SUNSET VILLAGE FILING NO. 4

CONSTRUCTION PLANS

EPC STORMWATER REVIEW COMMENTS
IN ORANGE BOXES WITH BLACK TEXT

MODIFIED FOR S.I.A. CD SET
RICHARD D. LYON, PE
ATWELL, LLC
DECEMBER, 2021
EPC PROJ.: CDR-21-008

POND A – SECTION 1
N.T.S.

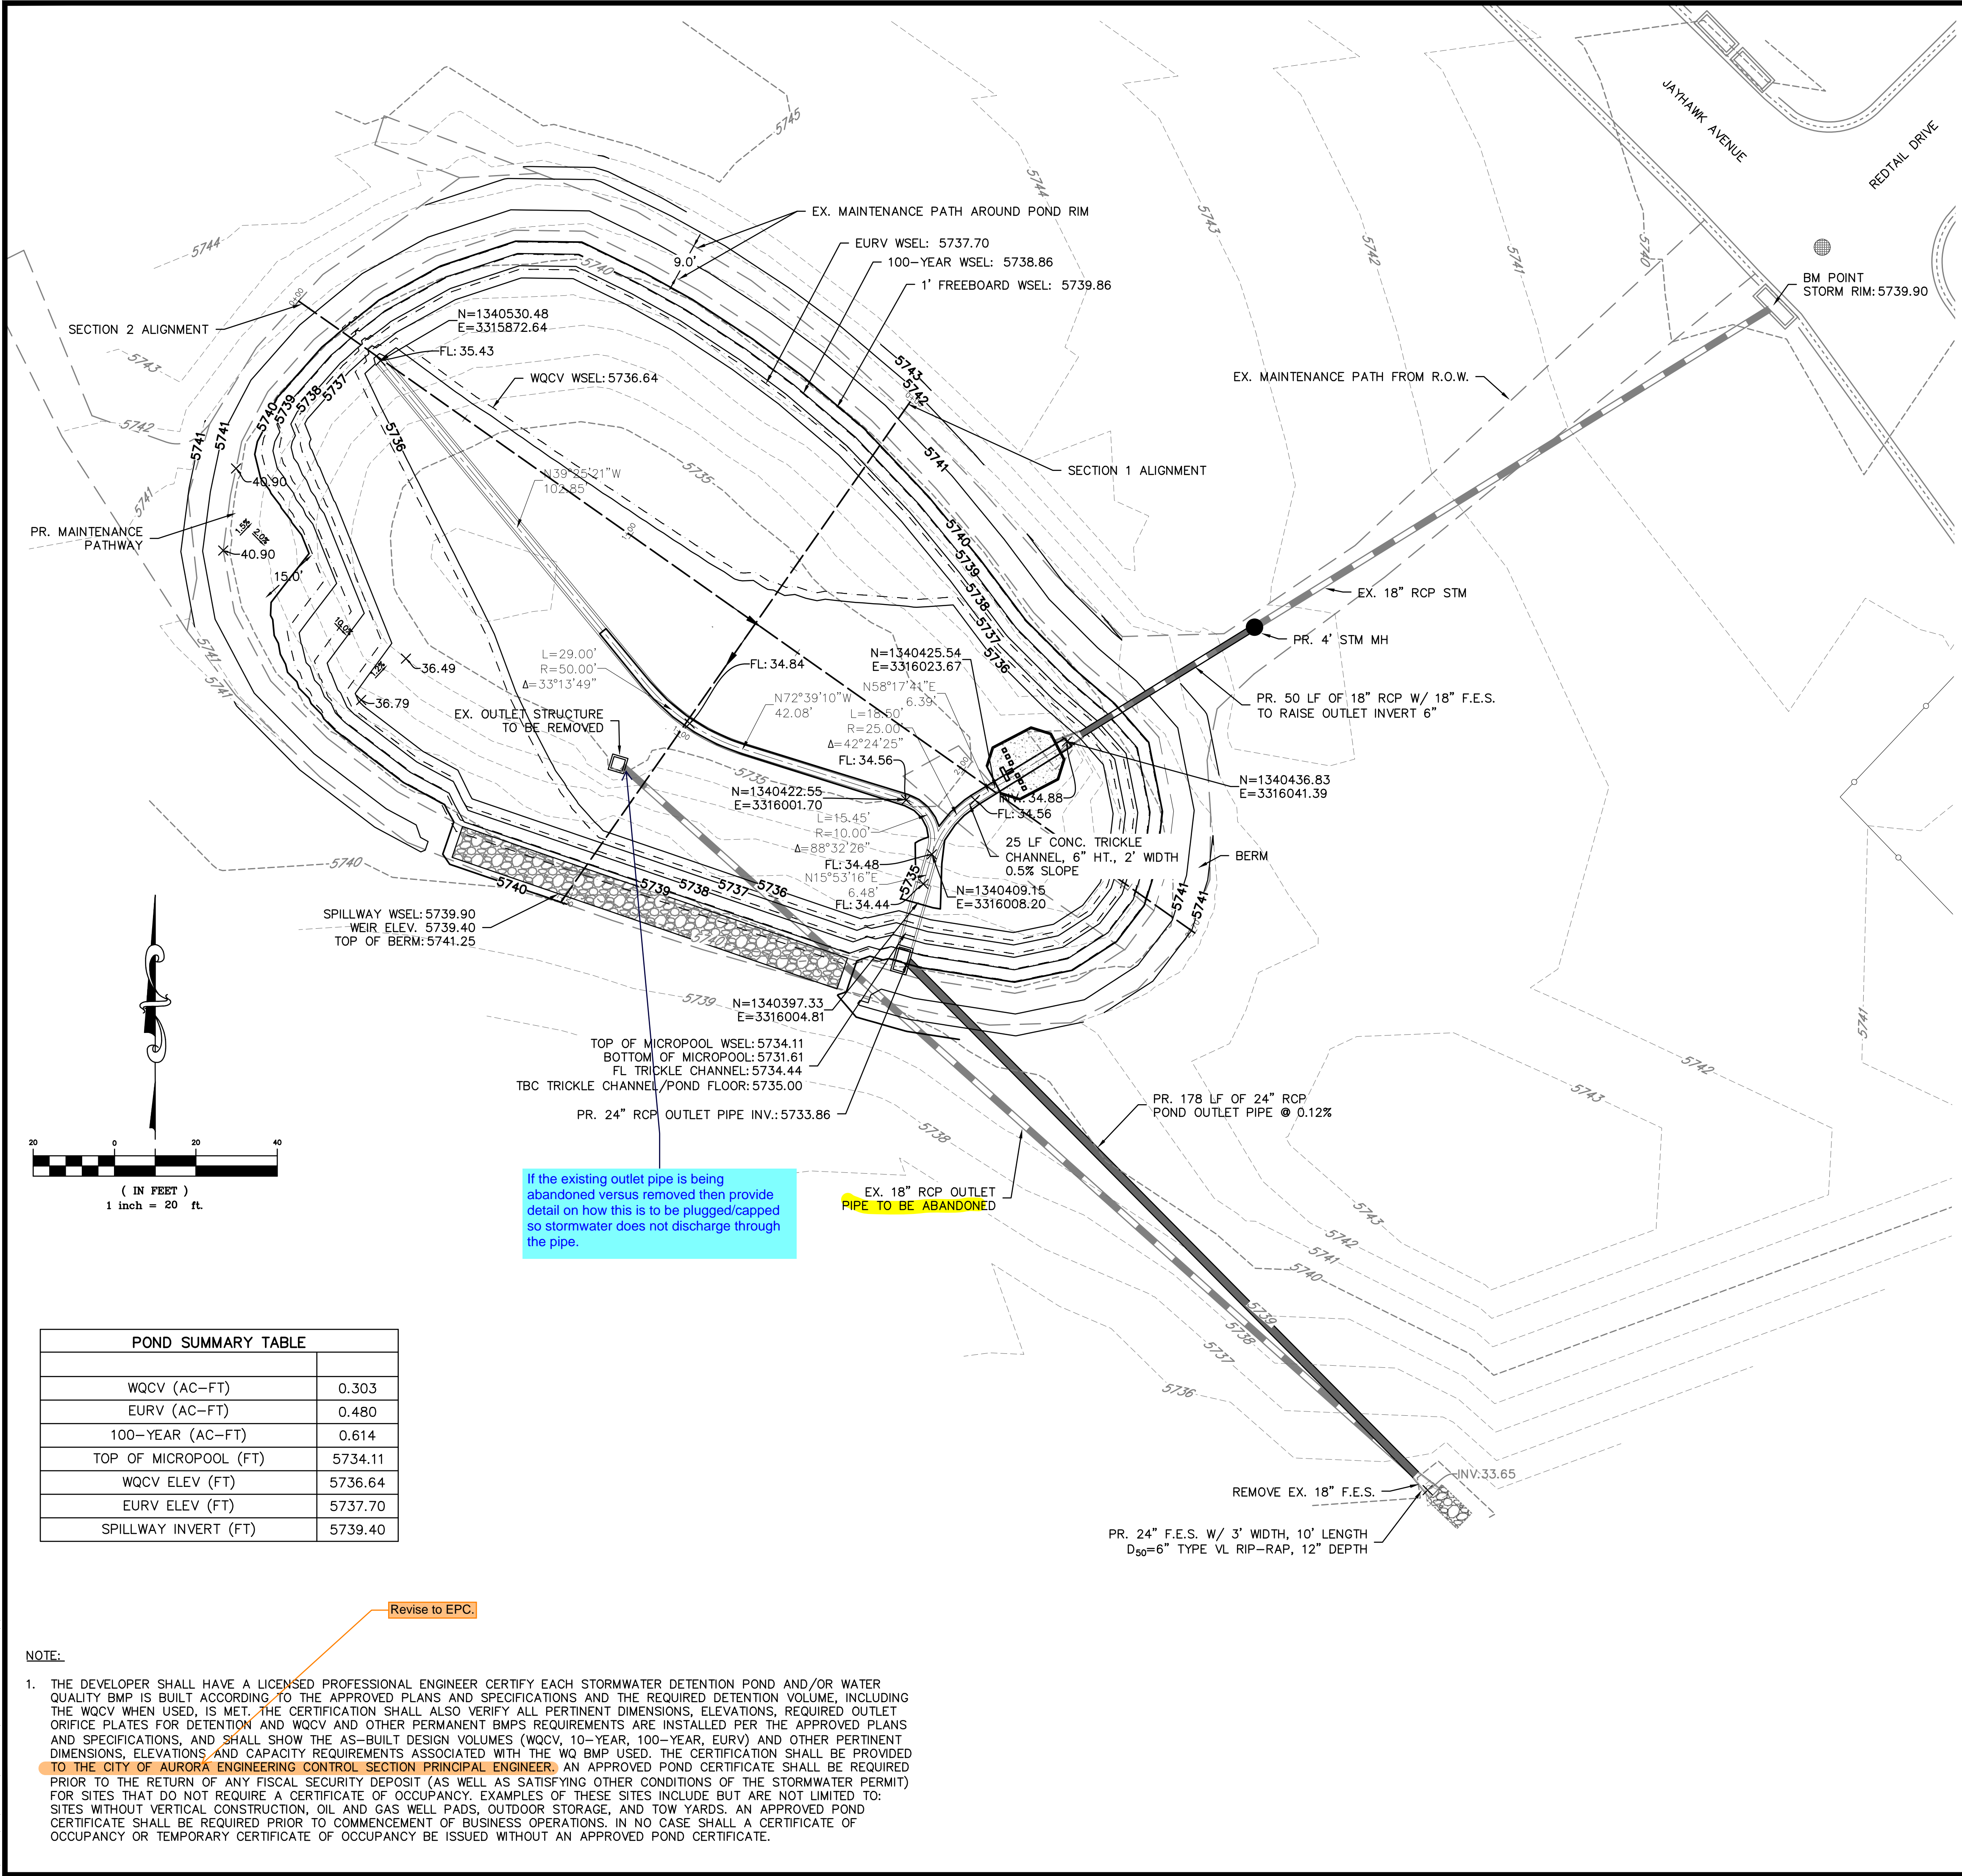
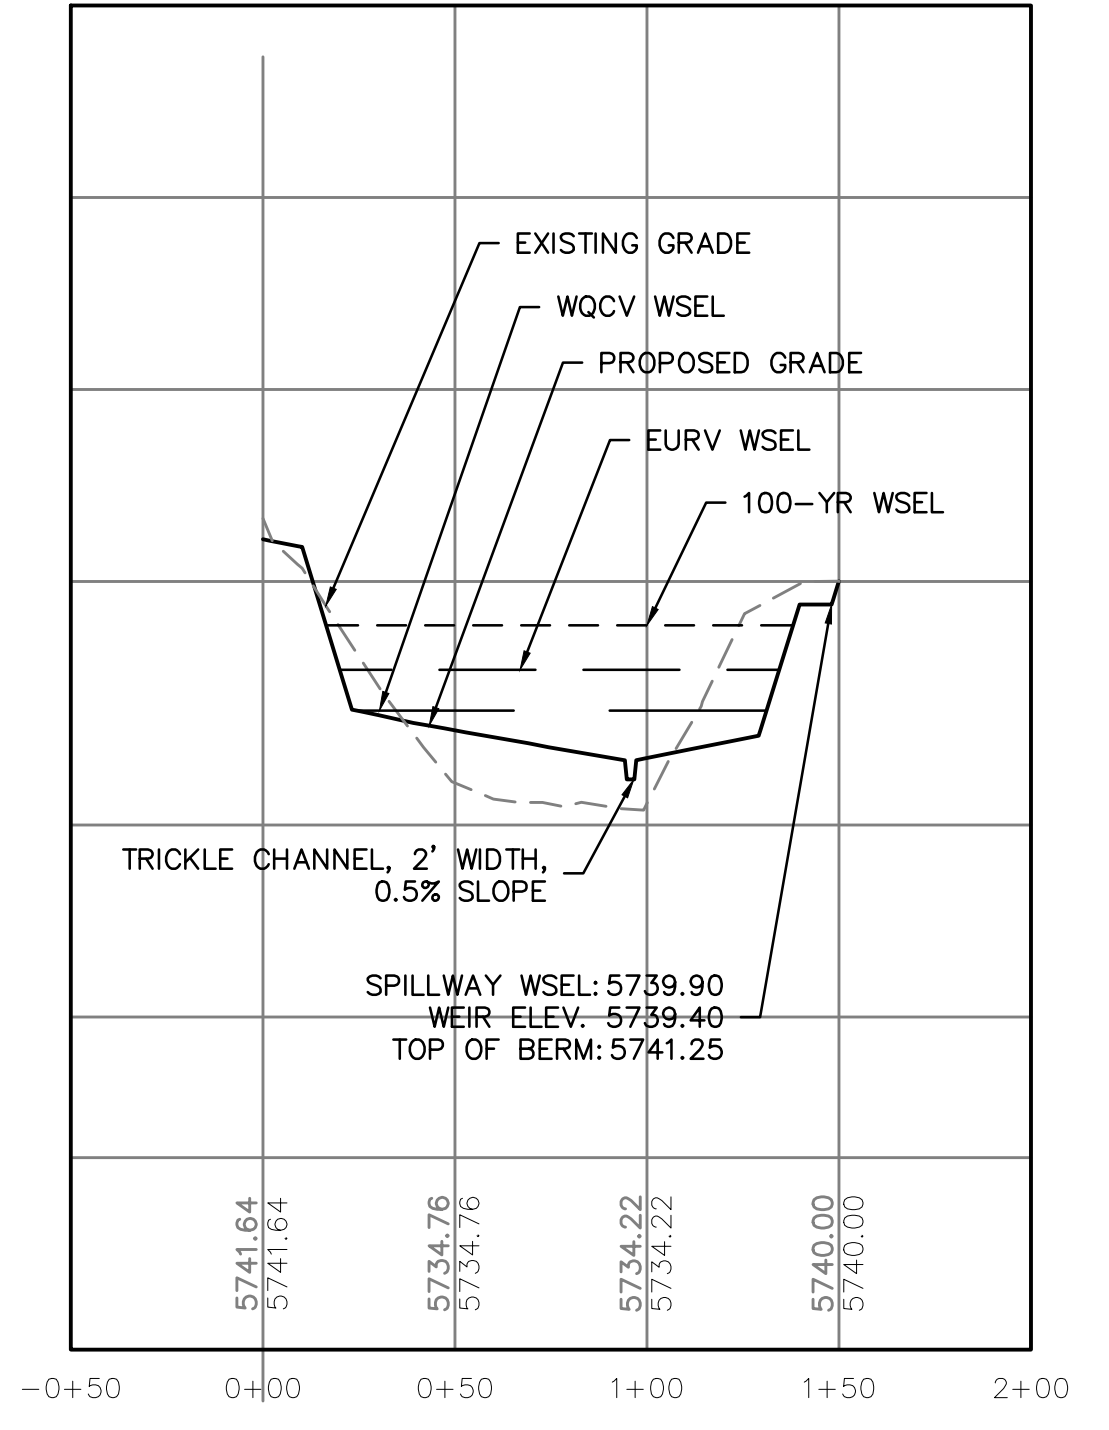
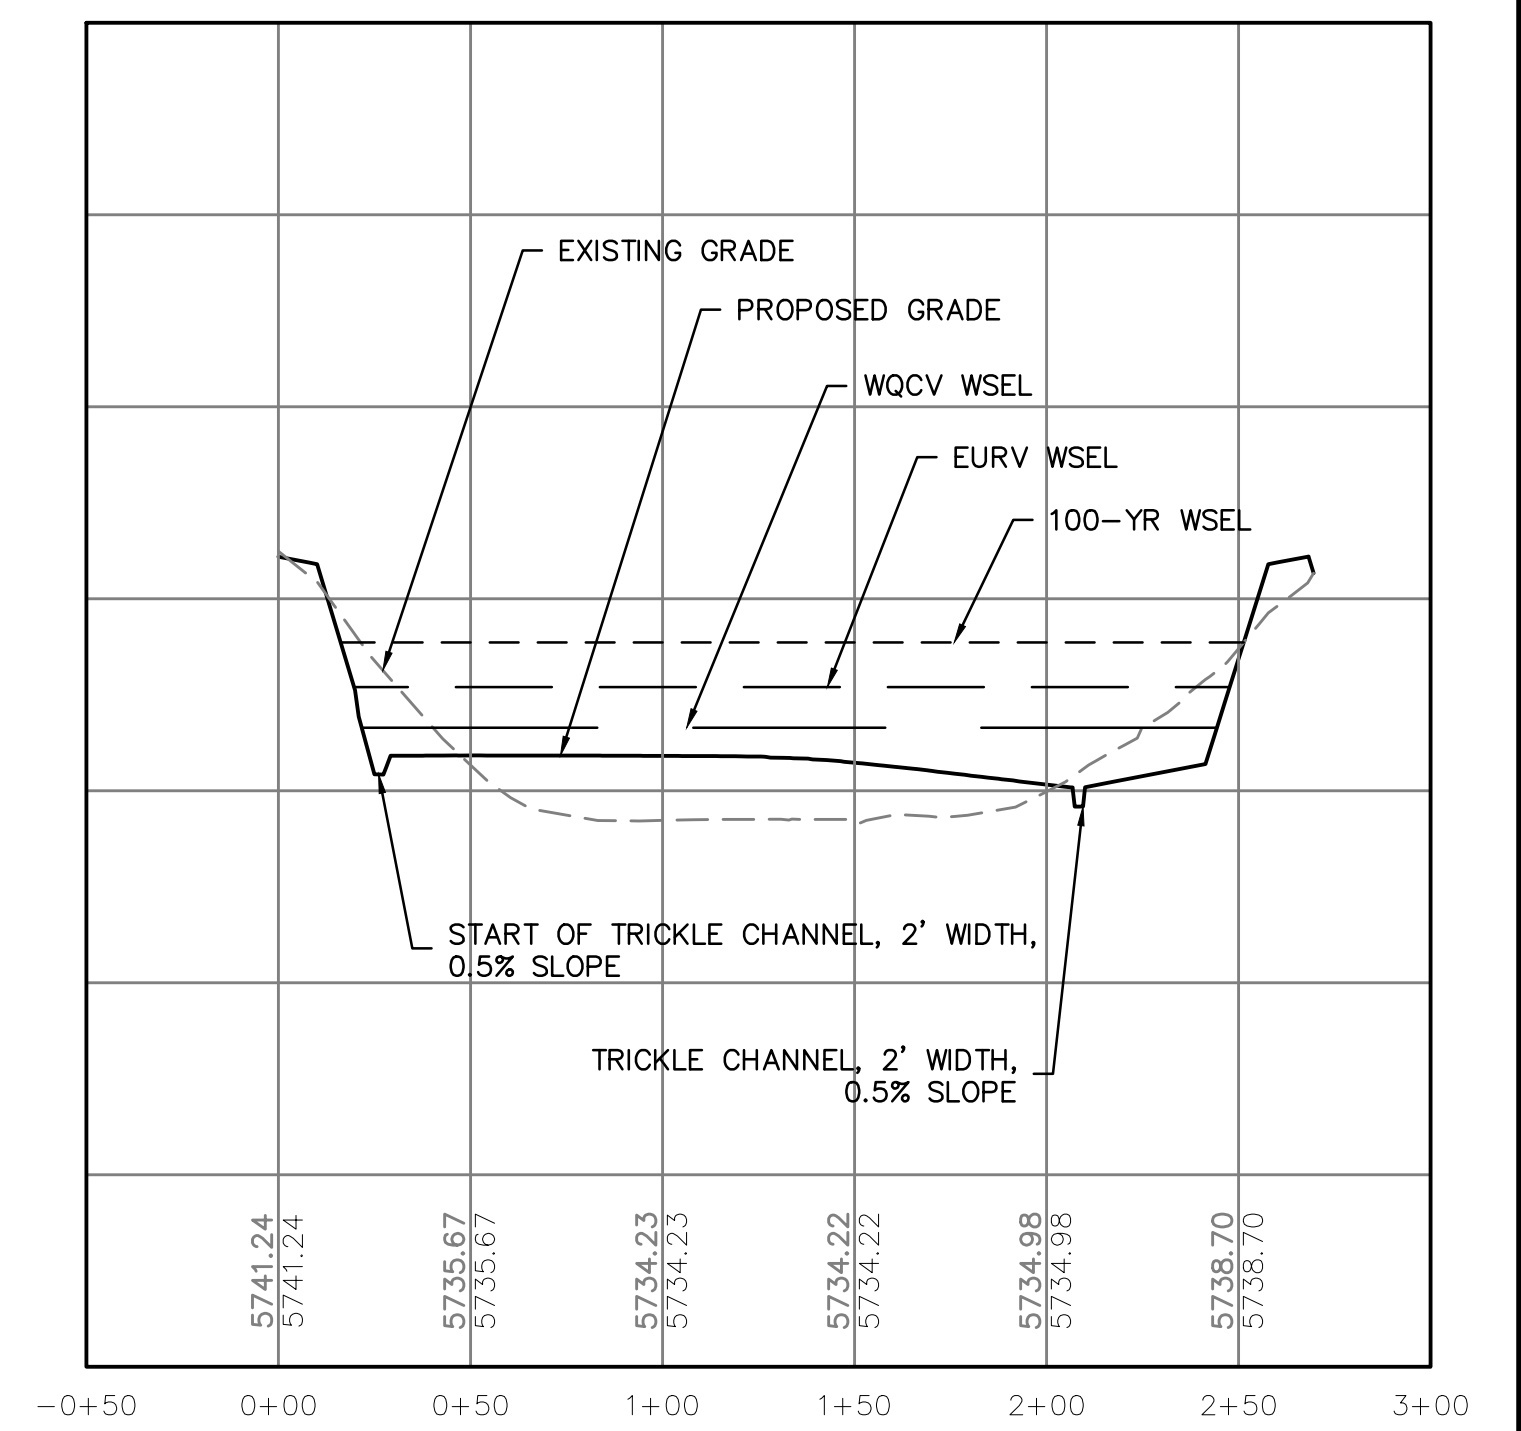
If the existing outlet pipe is being abandoned versus removed then provide detail on how this is to be plugged/capped so stormwater does not discharge through the pipe.

Revise to EPC.
